FINAL PLAT OF HANLEY SECOND ADDITION

AN ADDITION TO WICHITA, SEDGWICK COUNTY, KANSAS

Re: S/D 98-5 -- One-Step Final Plat of HANLEY 2ND ADDITION

STAFF REPORT

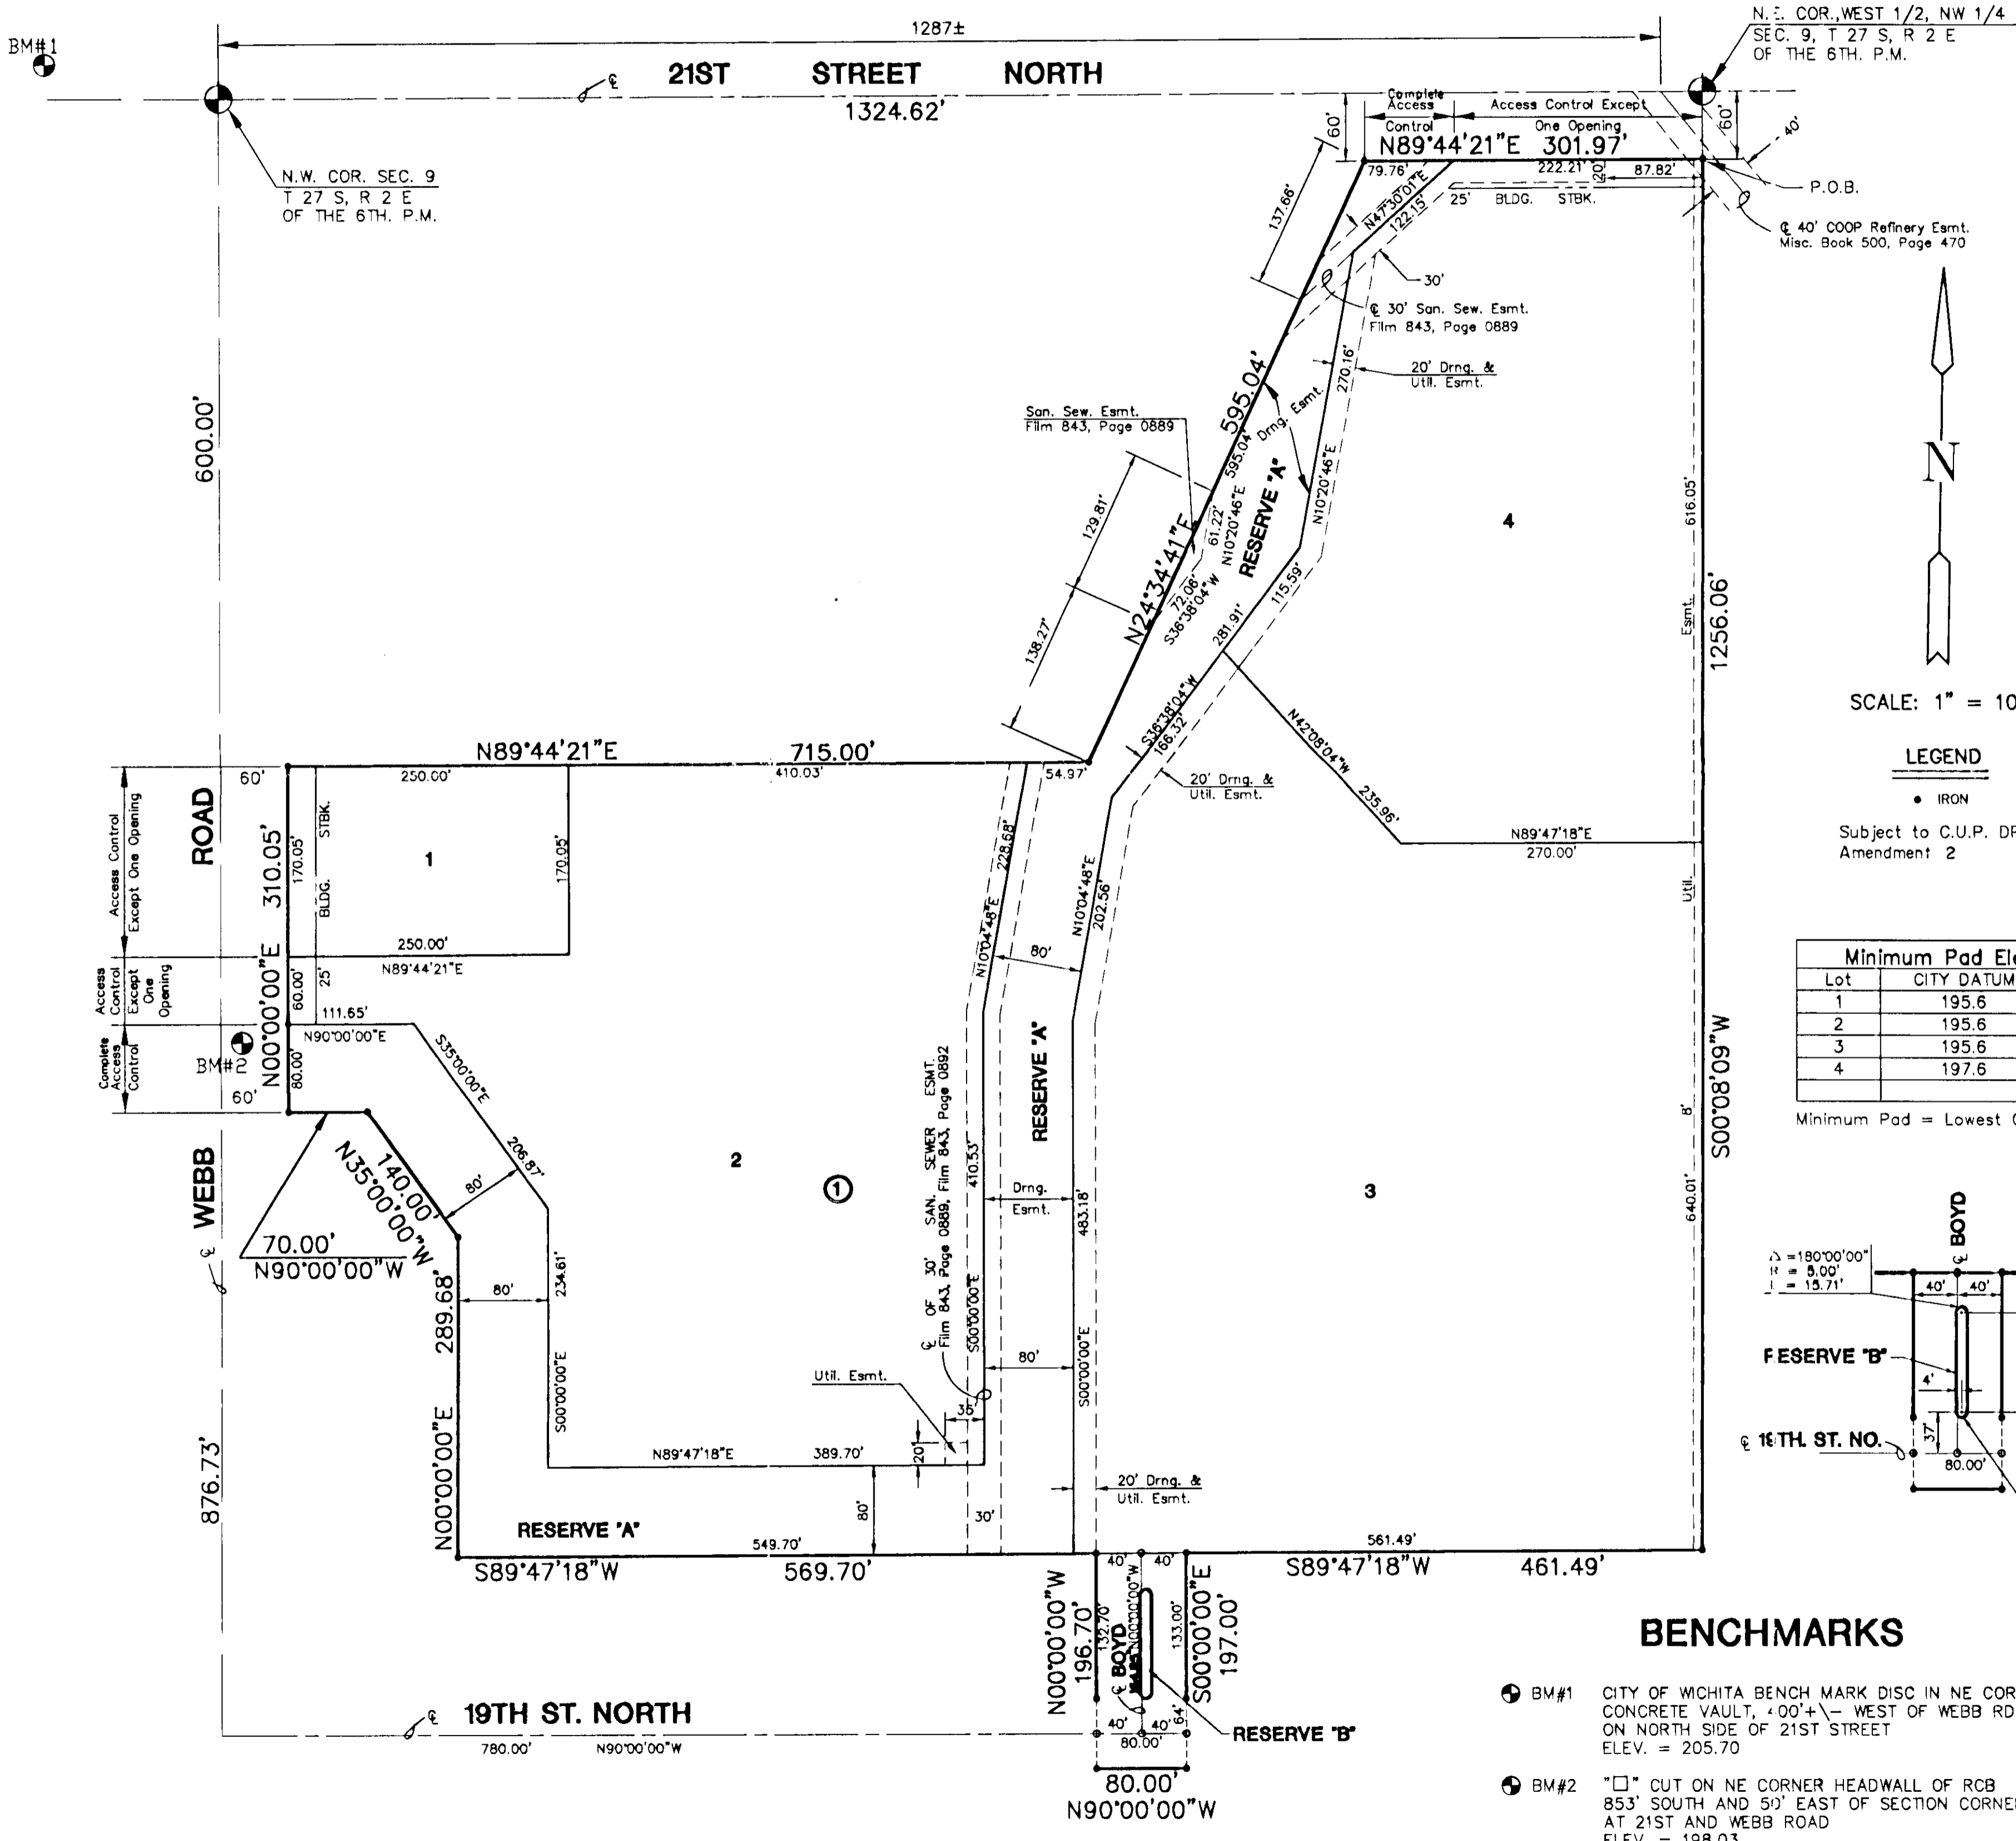
- A. **City Engineering** needs to comment on the situation involving existing guarantees for this site and requirements for providing new guarantees. **A guarantee is required for the paving of 19th Street. The existing paving petition for 21st Street North will need to be revised.**

- C. **City Engineering** needs to comment on the status of the applicant's drainage plan. **The drainage plan is approved.**
- D. As required by the CUP, the Applicant has previously submitted a petition for accel-decel lanes and left-turn lanes to serve entrances from 21st Street North and Webb Road. **Traffic Engineering** needs to indicate if any changes in the conditions for existing guarantees for improvements to 21st Street North and Webb Road are required due to this replat; in addition to the need for a guarantee for improvements to 19th Street North. **The existing paving petition for 21st Street North will need to be revised. Traffic Engineering has required a northbound deceleration lane along Webb Road to serve the driveway for office development. A decel lane on 21st Street for eastbound traffic to the easternmost driveway is also required.**

- E. **Traffic Engineering** needs to comment on the acceptability of the access controls. The plat denotes two openings from Webb Road and one opening from 21st Street North. This does not correspond with the CUP, which denoted one opening from Webb Road. Approval of this

- F. This plat involves access to a multi-family lot (lot 3) through land zoned for Single-Family use. Unless a public street is constructed, a zone change or conditional use will be needed.

- G. ✓ The final plat tracing should indicate that this plat is subject to DP-154 Amendment 2.
- H. ✓ The legal description in the platting binder (dated 1995) does not correspond with the land being platted. An updated platting binder should be submitted indicating current outstanding property taxes and easements.

- I. ✓ The legal description in the plattor's text needs to be revised to include the northern line of the plat.
- J. ✓ A 25-foot front yard setback from 19th Street North shall be denoted on Lot 3.

- K. ✓ A surveyor's signature line needs to be added on the final plat tracing.
- L. ✓ The MAPC Chair needs to be revised to read Richard E. Lopez.
- M. ✓ The language "complete access control" should be replaced with "access control" where openings are indicated.

- N. ✓ The centerlines of Webb Road and 21st Street North should be indicated by "CL".
- O. ✓ The applicant shall submit an avigational easement covering all of the subject plat and a restrictive covenant assuring that adequate construction methods will be used to minimize the effects of noise pollution in the habitable structures constructed on subject property.

- X. The representatives from the utility companies should be prepared to comment on the need for any additional utility easements to be platted on this property. *KGE and Southwestern Bell have requested additional easements.*

variation would require an adjustment to the CUP. Traffic Engineering has approved the access controls. One additional opening along Webb Road was permitted for this plat due a reduction of one opening north of this site.

Applicant has indicated a public street will be constructed. The final plat tracing shall denote said dedication of right-of-way and a petition shall be submitted guaranteeing paving.
